Title: **STAGE 1 ROAD SAFETY AUDIT**

**Primary Care Centre & Nursing Home, Moygaddy, Co. Meath.**

Client: **OCSC Consulting Engineers.**

Report reference: **1388R02**

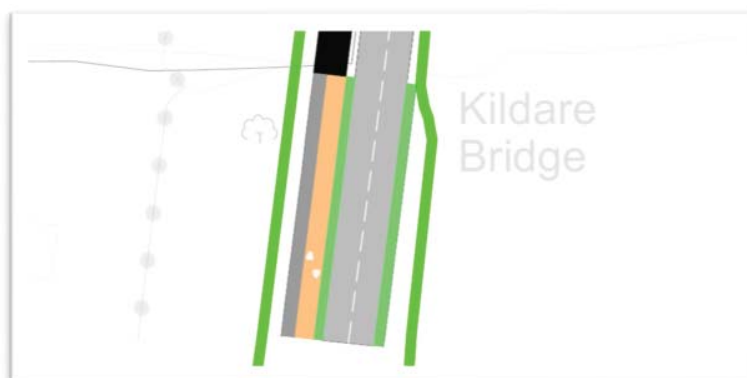
General Comment tie-in points

Details have not been provided of how the cycle track and footpaths will tie in at the scheme extents. Cyclists and pedestrians will have to cross the carriageway to access the facilities. Without suitable transitions from off road to on road and suitable crossing facilities there is a risk that pedestrians and cyclists will be struck by passing traffic.

It is recommended that suitable transitions and crossing facilities be provided. Where this scheme ties in with the other planned scheme to the north a transitional arrangement should be provided should construction of that scheme not proceed.

3.1	Y	Y	The proposed cycle lane across Kildare Bridge will be updated to tie in the existing carriageway R157 and at south cyclist will join carriageway

Drawing S665- OCSC-1B-MH-DR-C-0111 S2 P01 Sheet 2 of 3, Side road cross section.

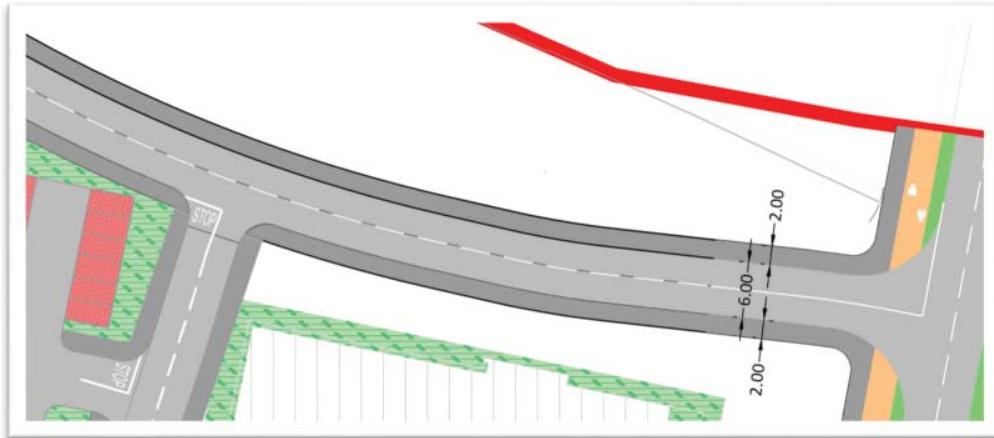
There are no dedicated cycle facilities along the proposed side road. The side road will be a busy area with vehicular traffic when fully developed and this will increase the risk for cyclists.

It is recommended cycle tracks be provided on both sides of the side road.

3.3	Y	N	It is not anticipated to have high volume of pedestrian and cyclist traffic. 2m wide shared use will facilitate pedestrian and cyclist movement	Yes

Drawing S665- OCSC-1B-MH-DR-C-0115 S2 P01 Visibility Splay at side road junction with R157.

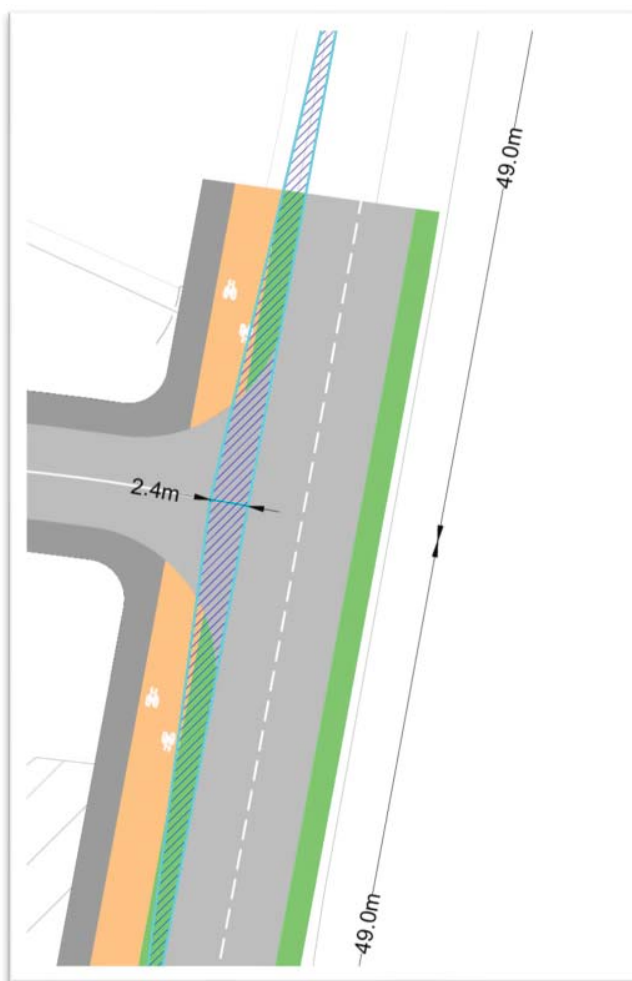
The visibility splay is shown for a 50km/hr urban design speed. The speed limit on the R157 is currently 80km/hr. There may be insufficient visibility to oncoming vehicles leading to side-impact or rear-end collisions.

It is recommended that visibility splays to the posted speed/design speed be provided.

3.6	N	N	The visibility splay is achieved for 50kmph. The new speed limit will be 50kmph once the new distributor road and development is completed.	Yes

Drawing S665- OCSC-1B-MH-DR-C-0112 S2 P01 Sheet 3 of 3, Carton Estate boundary wall.

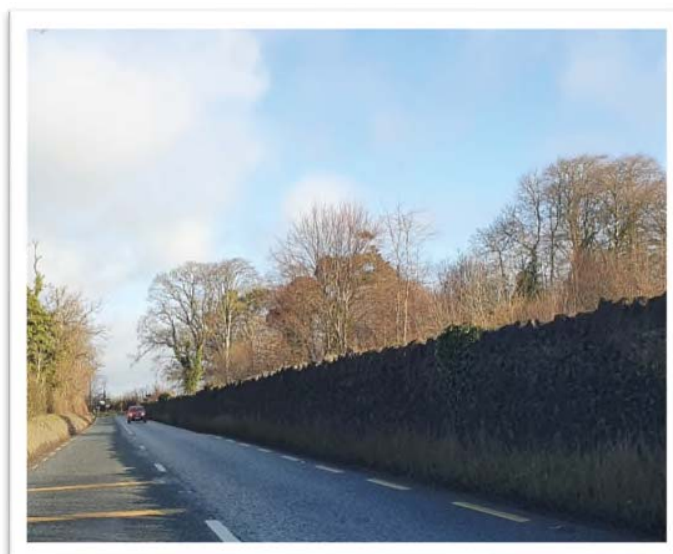
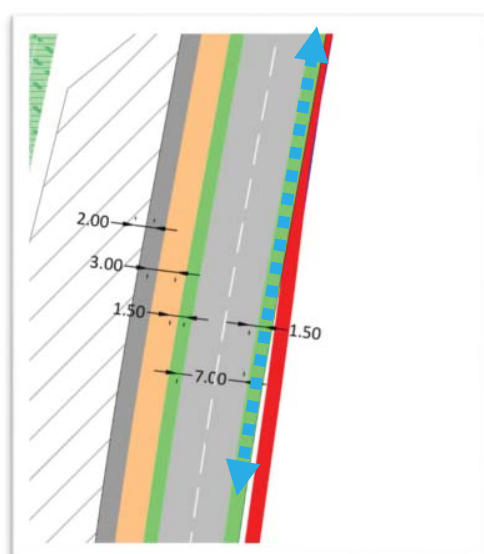
It is proposed to provide a 1.5m verge between the R157 and the Carton Estate boundary wall. The wall may be hazardous if struck by an errant vehicle.

It is recommended that a suitable Clear Zone be provided between the boundary wall and the R157 carriageway.

3.7	N	N	The proposed 1.5 m verge separation is an improvement to the existing condition, and the section of road is straight and the speed limit on the road will be reduced	Yes

once the new distributor road is completed.	
--	--	--	---	--
